UNITED STATES PATENT AND TRADEMARK OFFICE

APPLICATION NO.	FILING DATE	FIRST NAMED INVENTOR	ATTORNEY DOCKET NO.	CONFIRMATION NO.
10/650,416	08/29/2003	David Edwin Zapp	DEZ 001 P2	6570

Office Action Summary

DETAILED ACTION

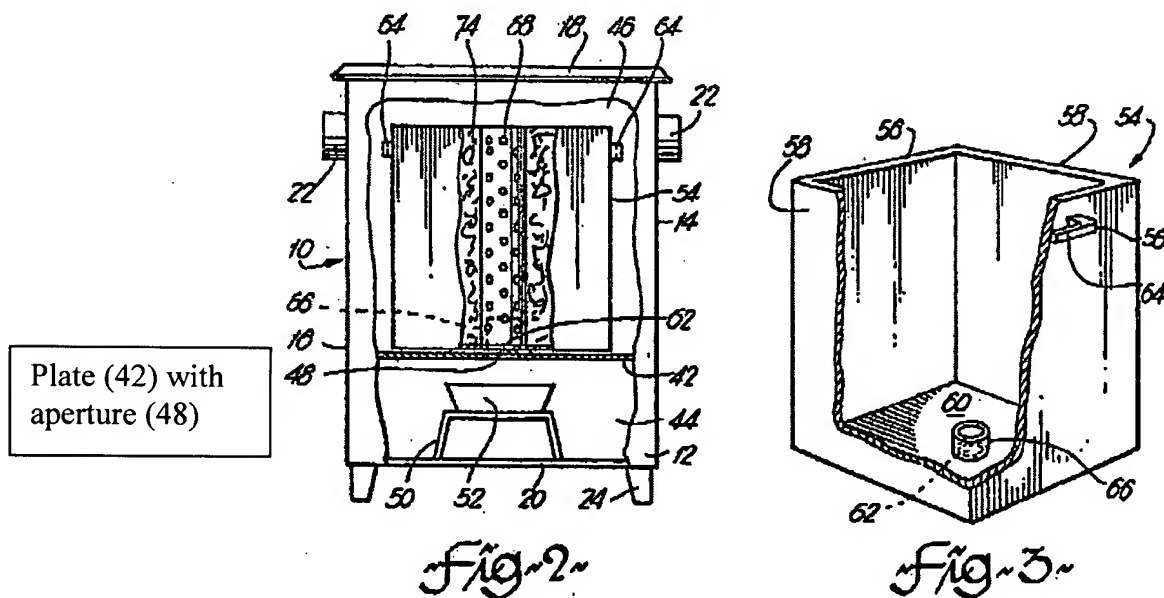
Claims 1, 2, 3, 7, 9, 10, 12, 13, 16 and 19 are rejected under 35 U.S.C. 102(b) as being anticipated by US004338915 (Martonfi).

In regard to claims 1, 3, 12, 13, 16 and 19, US004338915 (Martonfi) shows and discloses a charcoal fire starter including:

- a first chamber (10) having:
 - o a sidewall (12, 14, 16, etc.);
 - o a top edge (not referenced; contacting the top wall 18);
 - o a bottom surface (20); and
 - o a planar member (42, a grate (note shown; Note: "Open 50 can be replaced by a small grate (not shown) if the secondary combustion material is to be wood shavings, twigs, paper or the like.") disposed horizontally intermediate the top edge (at 18) and the bottom surface (20);
 - o the planar member having at least one aperture (48) extending from a top surface to a bottom surface;

- only one sidewall (12) having an aperture (34) formed therein intermediate the bottom surface (90) and the planar member (28); and
- a second chamber (54; figure 3) disposed above (figure 2), supported on and in cooperating relationship with the first chamber planar member (42) and having:
 - a sidewall (56, 58);
 - a top edge (not referenced); and
 - a planar charcoal supporting bottom surface (60) extending across the second chamber; and
 - the second chamber having one aperture (62, 66) formed therein; and
 - updraft facilitation means (68) atop and in contacting relationship to the second chamber charcoal supporting bottom surface, wherein the updraft facilitation means and spaced in totality inwardly of the second chamber sidewall, and having a sidewall with a plurality of apertures (70) extending therethrough.

U.S. Patent Oct. 28, 1975 Sheet 1 of 4 3,915,144

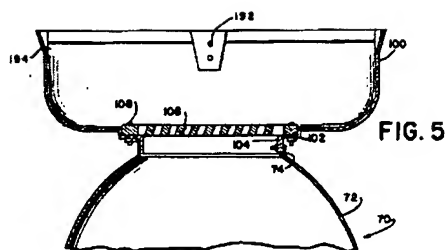
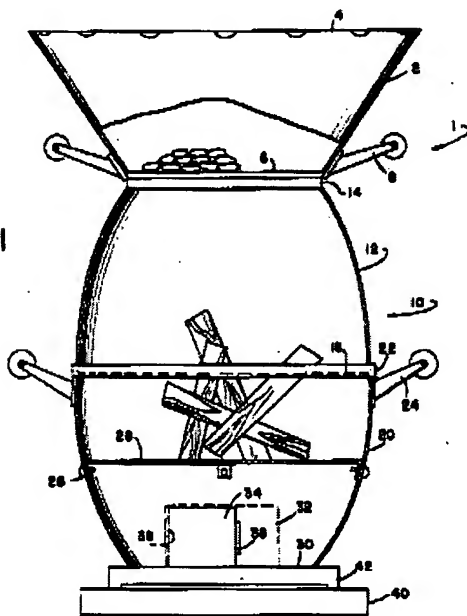
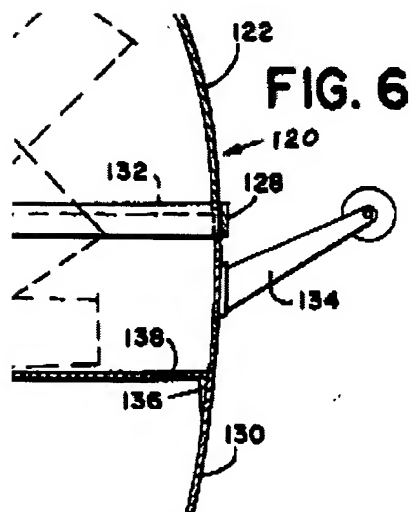
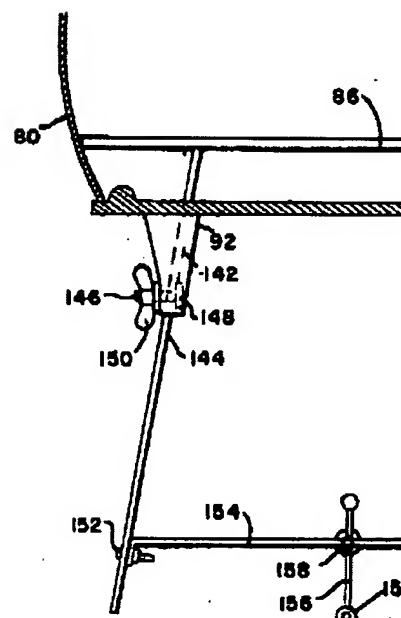
US003915144 (Tomita) shows and discloses a charcoal fire starter including:

- a first chamber (20; 80; 130) having:
 - o a sidewall;
 - o a top edge (not referenced; contacting "Lower end 16"), and
 - o a bottom surface (90; see for example figure 8); and

- o a planar "grate" member (28, or 138) disposed horizontally intermediate the top edge (at 16) and the bottom surface (90);
 - o the planar "grate" member having at least one aperture extending from a top surface to a bottom surface (see for example planar "grate 106" (figure 5));

- o the sidewall (20) having at least one aperture (38) formed therein intermediate the bottom surface (90) and the planar member (28), and
- a second chamber (2,12; 52,72; 100,70; 112,122) disposed above and in cooperating relationship with the first chamber (20; 80; 130) and having:

- o a sidewall;
 - o a top edge (4); and
 - o a planar charcoal supporting bottom surface (i.e. – grate 6, or 106) extending across the second chamber and located above the first chamber planar member; and

- o the second chamber having at least one aperture formed therein (i.e.- the apertures necessarily present in the planar bottom surface grate 6, or 106).

US003915144 (Tomita) shows and discloses the invention substantially as set forth in the claims with possible exception to:

- the second, or upper most, chamber having an updraft facilitation means atop and in contacting relationship to the second chamber charcoal supporting bottom surface, wherein the updraft facilitation means and spaced in totality inwardly of the second chamber sidewall, and having a sidewall with a plurality of apertures extending therethrough.

In regard to claim 3, it is noted that the first chamber planar member (28) of **US003915144 (Tomita)** is a "grate" which necessarily includes apertures throughout its planar extent (for an example of a planar "grate" see element 106 of figure 5). Therefore any one of these grate openings, or apertures, located centrally of the grate meets the claim limitation that the "planar member has formed therein a centrally positioned aperture".

In regard to claim 5, the second chamber of **US003915144 (Tomita)** has a **flange member**, the flange member (22, or 128; see figure 6) forming the bottom edge of the second chamber sidewall, the flange member telescoping with the top edge (16, or 132) of the first chamber.

5,197,455

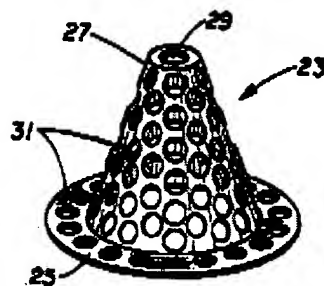
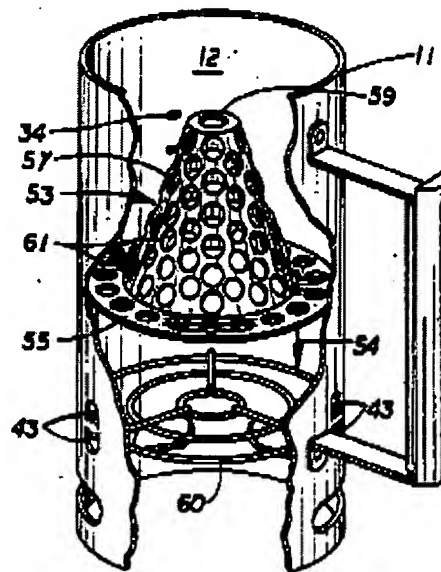
US005197455 (Tessien) teaches, from applicant's same charcoal ignition field of endeavor, placing a charcoal ignition draft facilitating means (11, 12) within a cooking grill for aiding in the initial ignition of the charcoal.

A. N. DURFEE
CHARCOAL IGNITER
Filed July 22, 1963

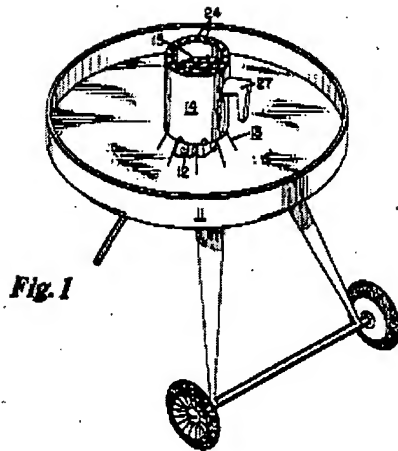
US003216379 (Durfee) teaches, from applicant's same charcoal ignition field of endeavor, placing a charcoal ignition draft facilitating means (14) having a plurality of support legs, within and supported on a cooking grill (11), for aiding in the initial ignition of the charcoal.

3,934,520

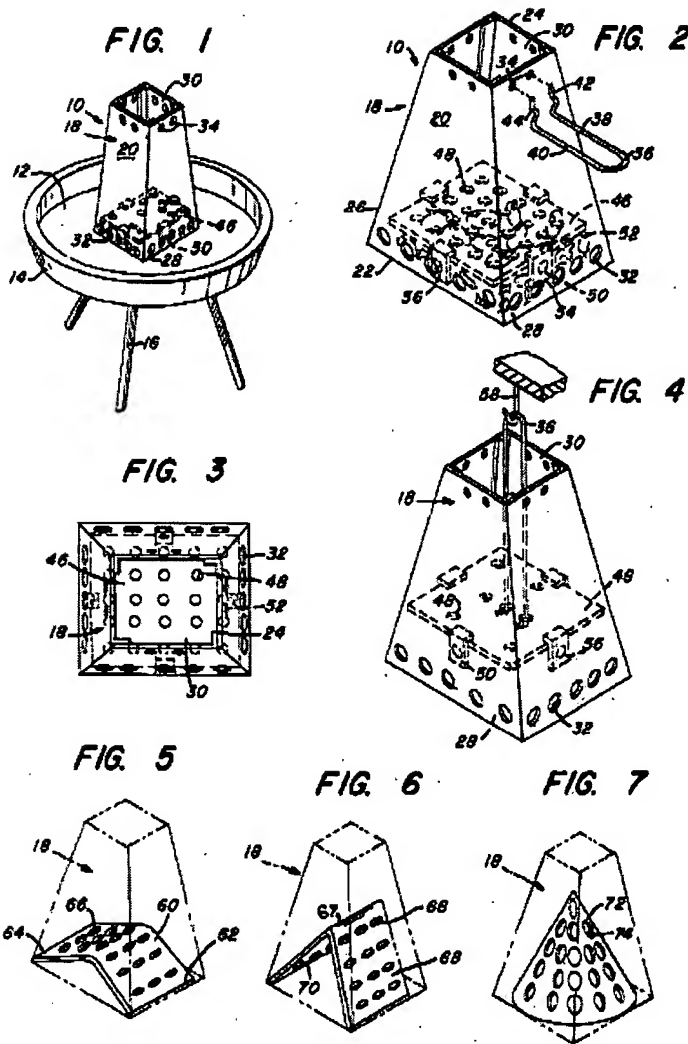
US003934520 (Brennen et al) teaches, from applicant's same charcoal ignition field of endeavor, placing a charcoal ignition draft facilitating means (10) having a plurality of support legs (21), within and supported on a cooking grill (12, 14), for aiding in the initial ignition of the charcoal.
